Invitation for Bid
April 10, 2018 3PM
(BUS) 17180410-1

Spartanburg Area Regional Transit Agency
17180410-1 3 Low Floor Heavy Duty Diesel Buses

Grande West Transportation is pleased to submit the following Requests and Approved Equals.

Request #: 7

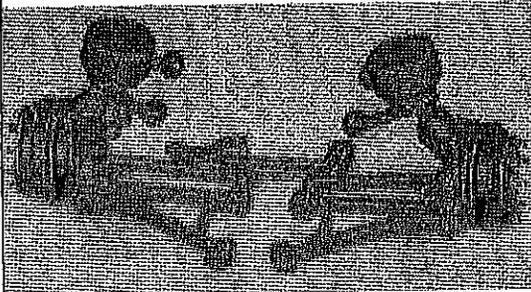
IFB: The front axle shall be of an I-beam suspension design, non-driving, with a load rating sufficient for the bus loaded to GVWR and shall be equipped with grease type front wheel bearings and seals.

Grande West: The proposed front axle is a "double wishbone independent suspension". Hub bearings are sealed. This design is lighter weight, heavy duty low maintenance design, and provides excellent handling and ride characteristics.

Agency requires front axle I-beam suspension

- 2 doors, 31 seated passengers
- 24 standees
- 2 fwd facing wheelchair positions

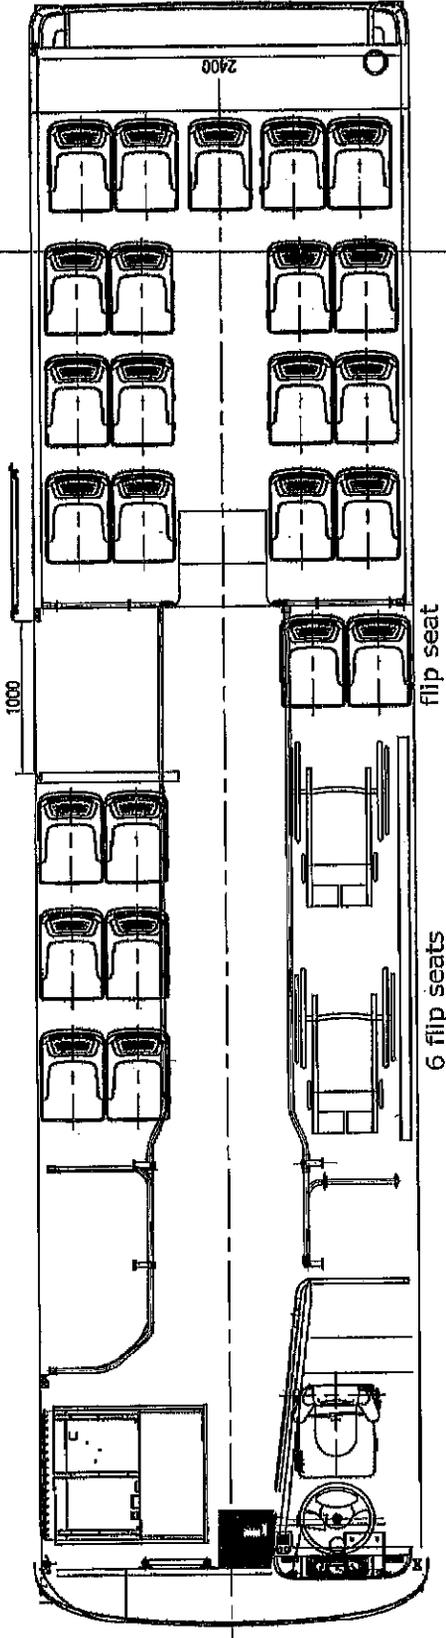
Request #: 13 Bidder: Grande West Transportation IFB Section: TS 72. Passenger Seating Page: 115	
Questions/clarification or approved equal: IFB: Passenger seating capacity with this arrangement shall be no less than 34 passengers. The transverse seat structure shall be fully cantilevered. Grande West: The proposed bus has a seating capacity of 31, with 2 Mobility Aid positions on the street side. The transverse seats are pedestal mounted. Refer to the following sample seating layout.	
Agency action:	<input checked="" type="checkbox"/> Approved <input type="checkbox"/> Denied <input type="checkbox"/> See addendum <input type="checkbox"/> See response below
Agency response:

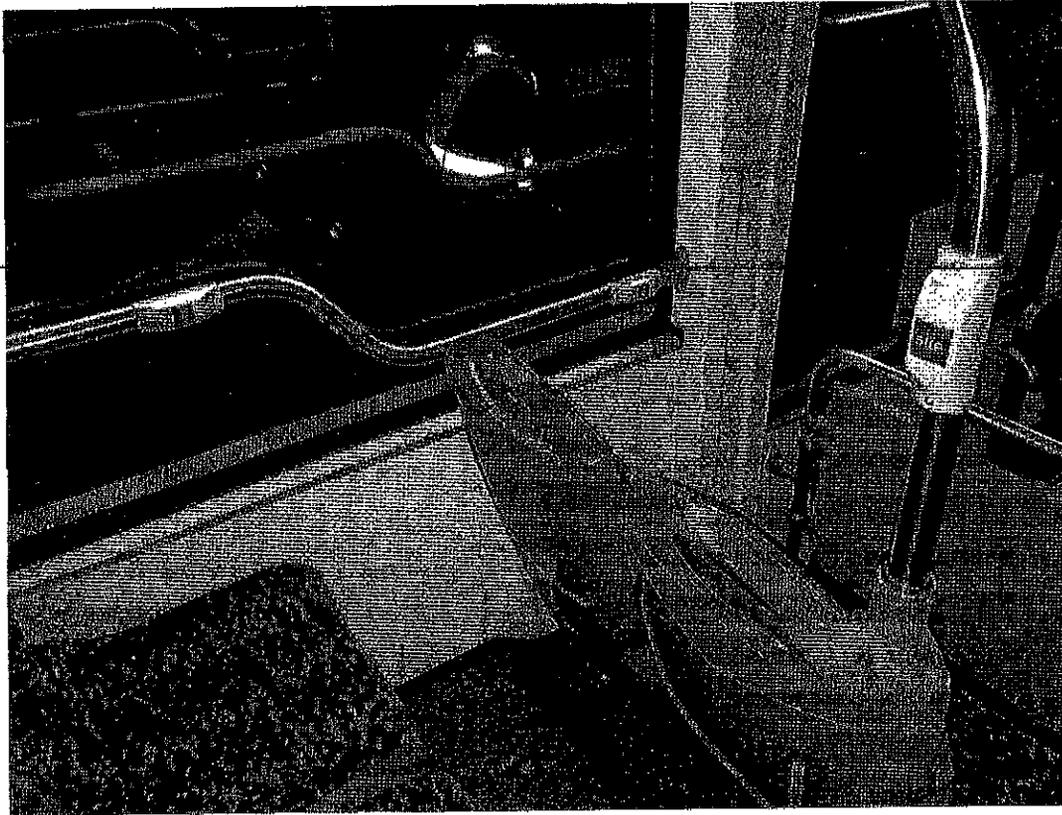
Request #: 16	
Bidder: Grande West Transportation	
IFB Section: TS 79. Passenger Stop Request	
Page: 126	
Questions/clarification or approved equal: IFB: Pull cord passenger signal	
Grande West: The Vicinity bus is equipped with minimum 10 "Stop Request" buttons located at convenient locations throughout the passenger seating area. We find the stop request buttons are very convenient, aesthetic, and lower maintenance, compared to pull cords. See photos following.	
Agency action:	<input checked="" type="checkbox"/> Approved <input type="checkbox"/> Denied <input type="checkbox"/> See addendum <input type="checkbox"/> See response below
Agency response:
